SUBJECT: DEPARTMENT OF WASTE RESOURCES: Contract Change Order Numbers 1 and 2 for the Southeast Drainage Channel Improvement Project at the Corona Landfill, District 2. [\$262,623.10 – Department of Waste Resources Enterprise Funds] (Nothing Further Required under CEQA)

Project: Construction of the Southeast Drainage Channel Improvement Project at the Corona Landfill
Sheet 1 of 4

CONTRACT CHANGE ORDER NO. 1

CONTRACT CHANGE ORDER NO. 2

PROJECT: Project Drawing/Channel - Drain
 TITLE: Corona Landfill Southeast Drainage Channel Improvement Project
 SHEET: 8 OF 20

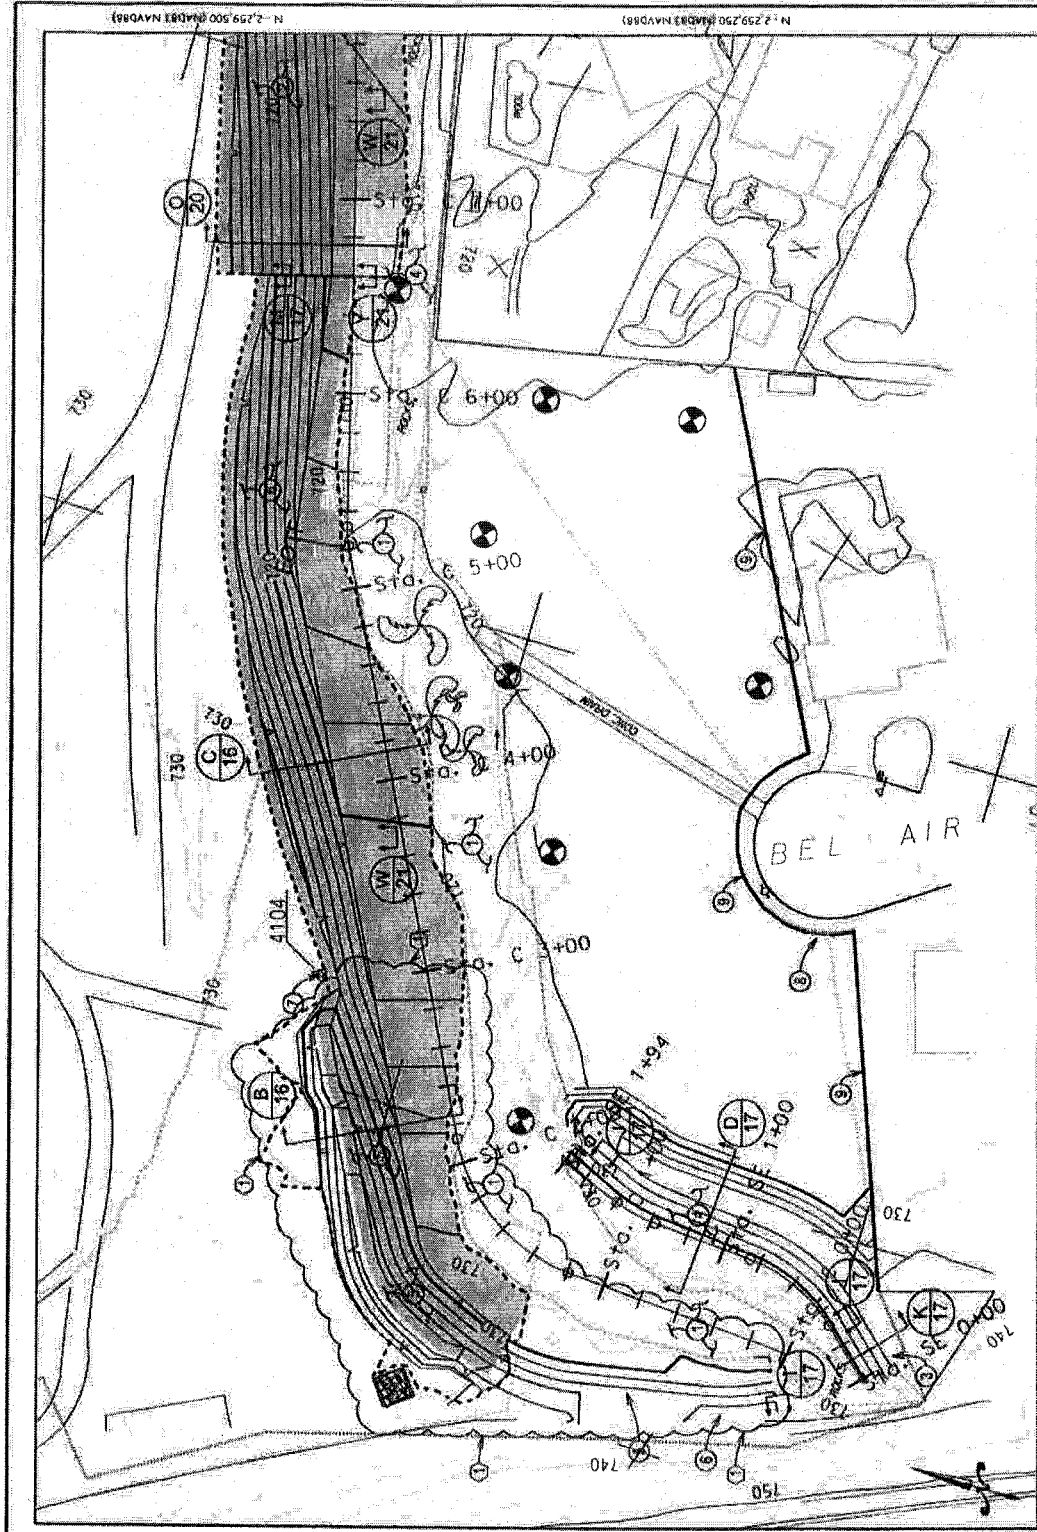
The County shall direct the Contractor to place up to 30,000SF of drainage gravel and quarter or half ton riprap rock, depending on the location in the channel (as shown in Project Drawing Sheets 8, 11, and 14), from the onsite riprap stockpile over graded areas within the channel outside the ACB limits to protect the channel from erosion. A total of ten (10) additional Contract Working Days shall be added to the Contract for this work. The placement of the drainage gravel shall be paid under the agreed upon unit price of \$2.05/SF for a total of \$61,500. The placement of the

quarter ton and half ton riprap rock in the within the grading limits and outside of the ACB limits shall be paid under Time and Materials. The Contractor shall be instructed to use the onsite stockpiled quarter ton riprap until it runs out before purchasing riprap to place in the channel. Placement of the riprap in the channel, including any material purchase shall be paid as Force Account work under General Provisions Section 7.3 and shall not exceed \$159,000. The locations of the gravel and rock placement are shown on revised Project Drawing Sheets 8, 11, and 14 and the details for the rock placement are shown on Project Drawing Sheets 16, 20, and 21.

NO.	REVISION	DATE
1	Revised Grading Plan and Alignment	8/9/17
2	RMW Floodplain connects with riprap (ripap)	8/9/17
3	Remove fence and construct block wall	8/9/17
4	Riprap over graded areas of the channel	1/22/18

Corona Landfill
 Southeast Drainage Channel Improvement Project
 Details - Sheet 1

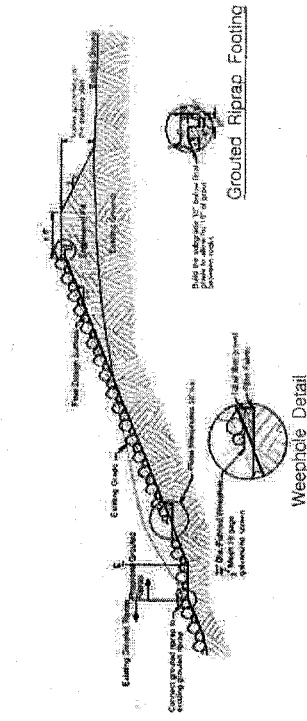
On January 4, 2018, CalTrans informed the County via email that the Encroachment Permit shall not be approved with the articulated concrete block (ACB) system. At this time, the County is working with CalTrans on an encroachment permit with an alternative revetment system, a rock slope protection. Therefore, the Contractor shall not install ACB within the CalTrans Right-of-Way limits. Instead of the ACB terminating in a connection to the concrete channel inlet as initially designed, the ACB limits shall now terminate in an ACB Flank Termination Trench outside of the CalTrans Right-of-Way limits, as shown on the revised Project Drawing Sheet 8 and shall be built according to detail H on the revised Project Drawing Sheet 17, attached to Contract Change Order No. 1. The Contractor shall use quarter ton rock stockpile onsite, if available, prior to hauling quarter ton rock for the ACB Flank Termination Trench. The contract shall be modified as follows:

- Bid Item No. 9 – ACB Contech Size 70L: The amount of ACB size 70L shall be decreased by 9,289SF, which is the amount of ACB that was to be installed within the CalTrans Right-of-Way on both the Northwestern and Southeastern Floodplains. This reduces the total quantity from 64,206SF to 54,917SF, reducing the cost of Bid Item No. 9 by \$158,841.90.
- The ACB Flank Termination Trench shall be paid as force account work and shall not exceed \$6,100.
- Bid Item No. 11 – Earthwork Backfill ACB shall be reduced by 8,454SF, reducing the cost by \$4,227.
- Bid Item No. 12 – Hydroseed shall be reduced by 2,358SF, reducing the cost by \$235.80.
- Bid Item No. 13 – Placement of Riprap Rock over ACB shall be reduced by 2,807SF, reducing the cost by \$2,807.

NO.	REVISIONS	BY	APPROVED	DATE
1	AW Floodplain connects to the grouted riprap apron	SNL	AMC	8/26/17
2	Change the gravel designation to 1/4"	SNL	AMC	8/27/17
3	Change of the detail to	SNL	AMC	8/27/17
4	NW Floodplain does not connect to grouted riprap apron.	SNL	AMC	1/22/18
